FURNISHING APPL FOR AMEND FOR APPLICANT'S SUBMITTAL OF 10/13/77 WHICH
FORWARDED REPT ENTITLED "DESIGN AND SAFETY EVALUATION FOR REPLACEMENT OF
SPENT FUEL POOL STORAGE RACKS" AND ADDL INFO PROVIDED BY SUBMITTALS DTD
12/20/77, 03/14, 05/11 05/15, 06/06 AND 6/9/78

PLANT NAME: DUANE ARNOLD

This amendment to the DAEC submittal describes the temporary installation of two 8 x 10 spent fuel storage racks manufactured for Boston Edison's Pilgrim I plant in the Duane Arnold Energy Center (DAEC) spent fuel pool. The temporary installation of these racks is necessary to allow the discharge of all fuel from the reactor to facilitate repairs to the recirculation riser nozzle safe end. All conditions in the previous submittals apply to this amendment.

FIGURE 1

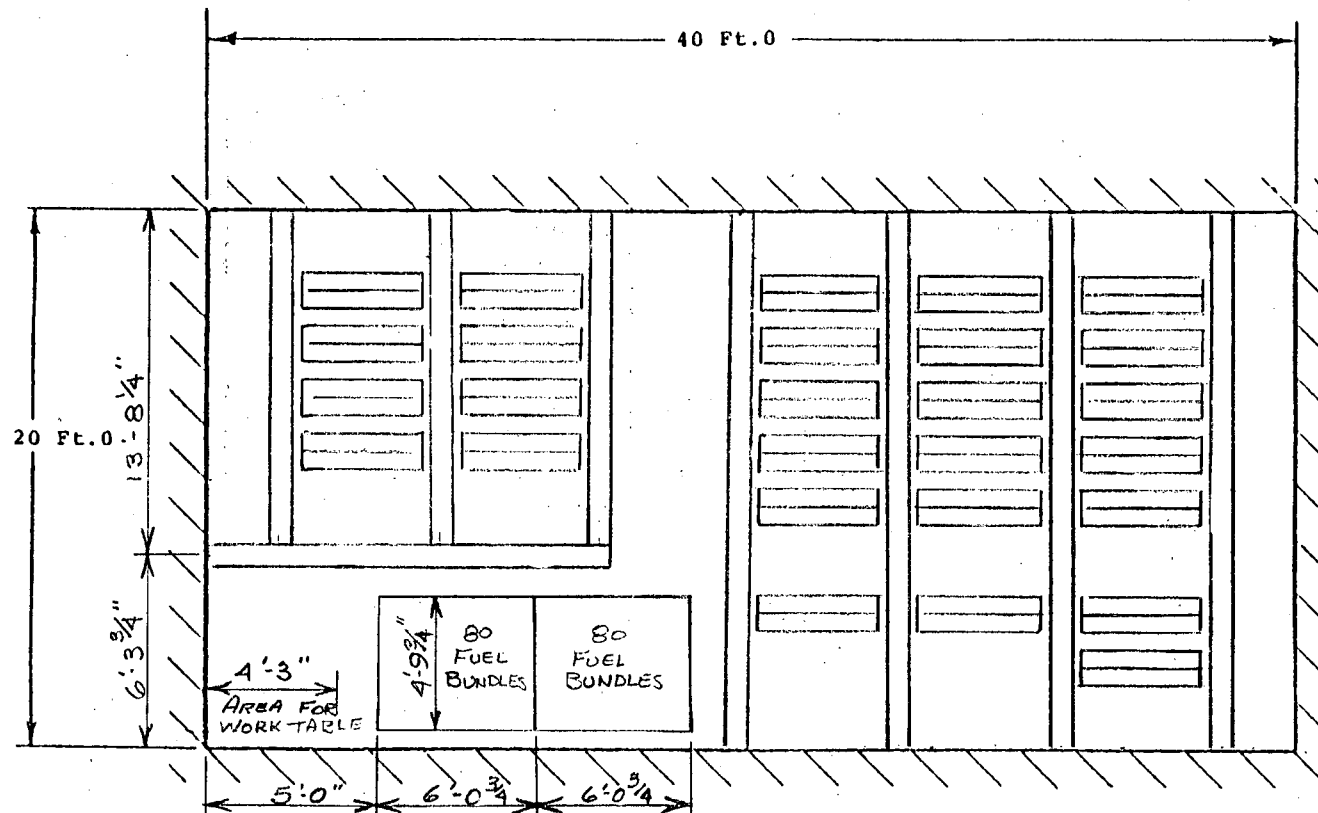
The temporary racks are of the Programmed & Remote Systems Corporation standard design for storing General Electric fuel and, except as noted below, are of the same design as the racks proposed for permanent installation in the DAEC submittal. The two racks will be placed in open areas in the fuel pool as shown in Figure 1. The temporary racks will have no effect on the existing racks in the pool nor will the existing racks affect the two temporary racks. No alterations to existing racks will be made. We have evaluated the effects of the physical differences upon the analyses results as reported in our application.

The rack geometry is such that no difference in the range of coefficients of friction used in the analysis of DAEC rack movement is required for the temporary racks. As the temporary 8 x 10 racks are heavier than the DAEC 8 x 10 and 8 x 8 racks and lighter than the other DAEC racks, the rack sliding displacement of 1.05 inches reported in the DAEC submittal is a bounding estimate of the movement of the temporary racks. The temporary racks will be placed a minimum of 6 inches from all equipment and pool walls and will have no effect on existing pool equipment.
